## **CNP UNITS 1 AND 2 IMPROVED TECHNICAL SPECIFICATIONS CONVERSION**

### **ITS SECTION 3.1 REACTIVITY CONTROL SYSTEMS**

**Revision 0**

**Current Technical Specification (CTS) Markup  
and Discussion of Changes (DOCs)**

Figure 3.1.3-1

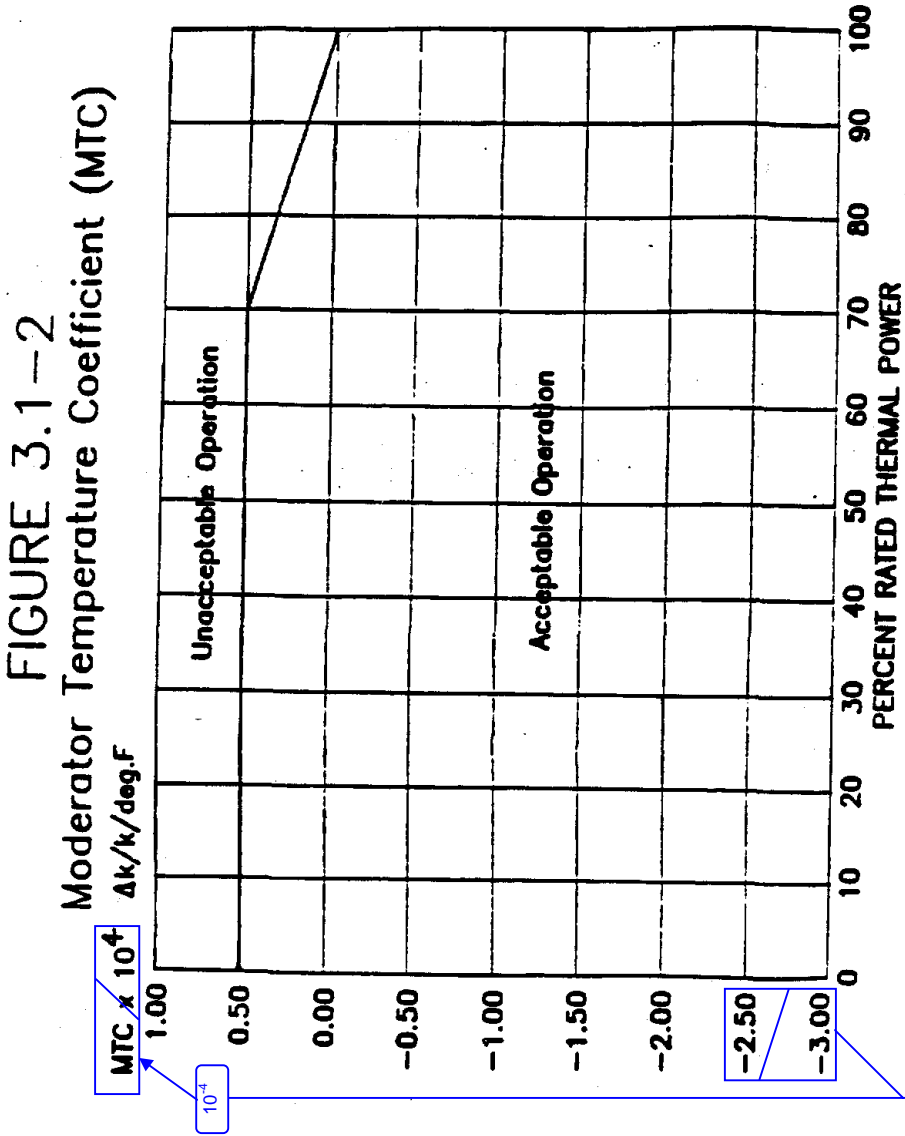
A.6

- A.6 CTS Figure 3.1-2 provides the maximum upper limit for MTC from 0% to 100% RATED THERMAL POWER (RTP). The Figure indicates that the value for MTC can vary from  $-3.00 \times 10^{-4} \Delta k/k/^{\circ}F$ . ITS Figure 3.1.3-1 includes the same curve however the range has changed to  $-2.00$  to  $1.00 (x 10^{-4} \Delta k/k/^{\circ}F)$ . This changes the CTS by using the correct exponential ( $10^{-4}$  in the CTS to  $10^{-4}$  in the ITS) and changing the range for MTC.

This change is acceptable because the requirements have not changed. The maximum upper limit for MTC when  $< 70\%$  RTP is  $0.50 \times 10^{-4} \Delta k/k/^{\circ}F$  and the maximum upper limit at 100% RTP is zero. This change is consistent with how similar values are presented in the ITS. Since this curve only provides the maximum upper limit there is no need to provide a wide range from  $-3.00 \times 10^{-4} \Delta k/k/^{\circ}F$  to  $1.00 \times 10^{-4} \Delta k/k/^{\circ}F$ . The lower value of  $-2.00 \times 10^{-4} \Delta k/k/^{\circ}F$  is sufficient. This change is designated as administrative because it does not result in a technical change to the CTS.

Figure 3.1.4-1

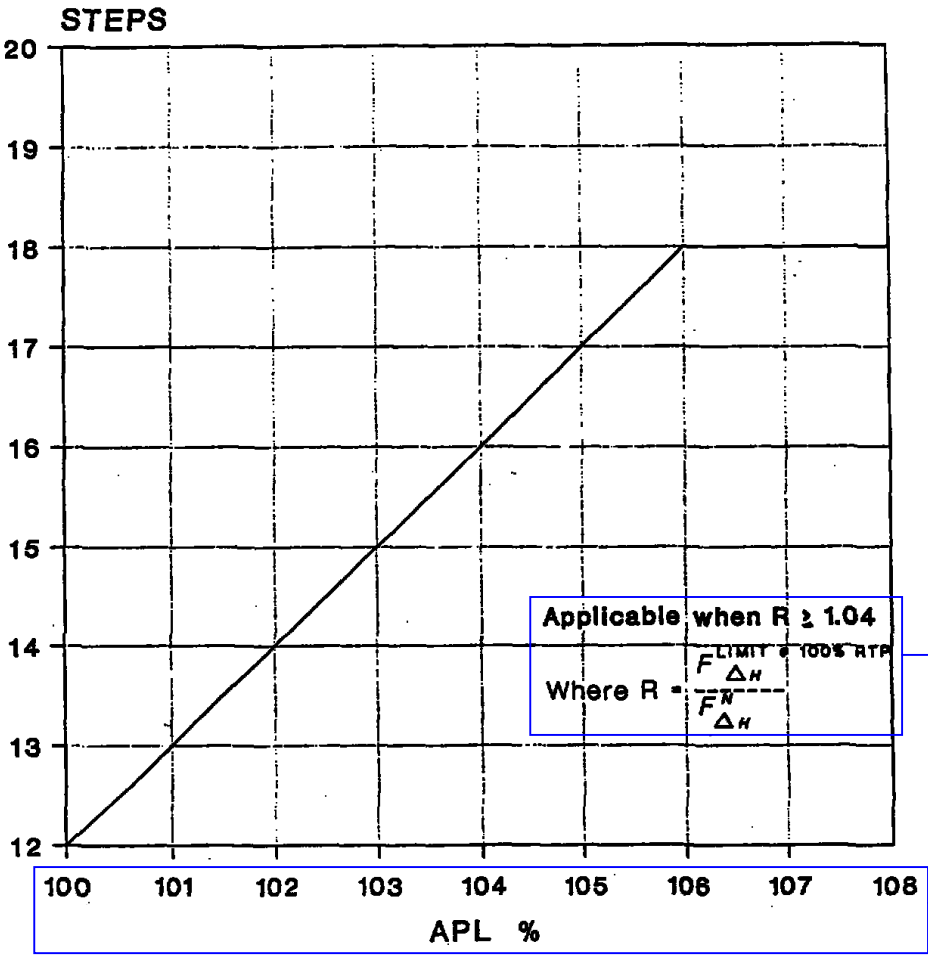
A.2

- A.2 CTS 3.1.3.1 specifies the rod misalignment limits for full length (shutdown and control) rods at a THERMAL POWER > 85% RATED THERMAL POWER (RTP) and at THERMAL POWER  $\leq$  85% RTP. At a THERMAL POWER > 85% RTP the allowed rod misalignment is +/- 12 steps or as determined from Figure 3.1-4. In addition, CTS 3.1.3.1 states that Figure 3.1-4 permits an allowed rod misalignment from +/- 13 steps (for ALLOWABLE POWER LEVEL (APL) equal to 101%) to +/- 18 steps (for APL greater or equal to 106%) provided the value of R (defined in Figure 3.1-4) is  $\geq 1.04$ . The R limit and definition are maintained in the ITS 3.1.4 Note and the range of rod misalignment allowed is maintained in ITS Figure 3.1.4-1. ITS LCO 3.1.4 states that with THERMAL POWER > 85% RTP, the individual rod positions shall be within 12 steps of their group step counter demand position or as determined from Figure 3.1.4-1, and the Note to ITS LCO 3.1.4 states the R limit and provides the definition. ITS LCO 3.1.4 does not contain the allowed misalignment range and ITS Figure 3.1.4-1 does not include the R limit or definition.

- A.6 CTS Figure 3.1-4, Allowed Rod Misalignment above 85% RTP, is based upon the current Allowable Power Level (APL) as determined in CTS 3.2.6. In addition, CTS 4.1.3.1.3 requires the allowed rod misalignment for THERMAL POWER > 85% RTP to be determined in conjunction with the measurement of APL as defined in CTS 4.2.6.2. The term APL has been changed to  $F_Q^W(Z)$ , as described in the DOCs for ITS 3.2.1. Therefore, in the ITS, the allowed rod misalignment is being based upon  $F_Q^W(Z)$ . In order to maintain a similar value in the ITS Figure as is in the CTS Figure, the term in ITS Figure 3.1.4-1 is  $(CFQ \times K(Z))/F_Q^W(Z)$ . In addition, the ITS does not include a specific SR in ITS 3.1.4 to calculate the new allowed rod misalignment every time an  $F_Q^W(Z)$  determination is made. This changes the CTS by using the term  $F_Q^W(Z)$  in lieu of the term APL, and not including a specific SR to calculate the allowed rod misalignment every time  $F_Q^W(Z)$  is determined.

The purpose of the details of CTS 3.1.3.1 is to clarify the details provided in the CTS Figure. However, the information provided in the two locations is duplicative. This change is acceptable because the technical requirements have not changed. The R limit and definition are maintained in the ITS 3.1.4 Note and the range of rod misalignment allowed is maintained in ITS Figure 3.1.4-1. Since the details are duplicative there is no reason to maintain the information in both locations. This change is designated as administrative because it does not result in technical changes to the CTS.

This change is acceptable since, as described in the DOCs for ITS 3.2.1, the term  $F_Q^W(Z)$  is analogous to APL. Also, the specific SR is not needed because each time the  $F_Q^W(Z)$  Surveillance is performed in ITS 3.2.1, the allowed rod alignment limit (if using ITS Figure 3.1.4-1) must be established based on the
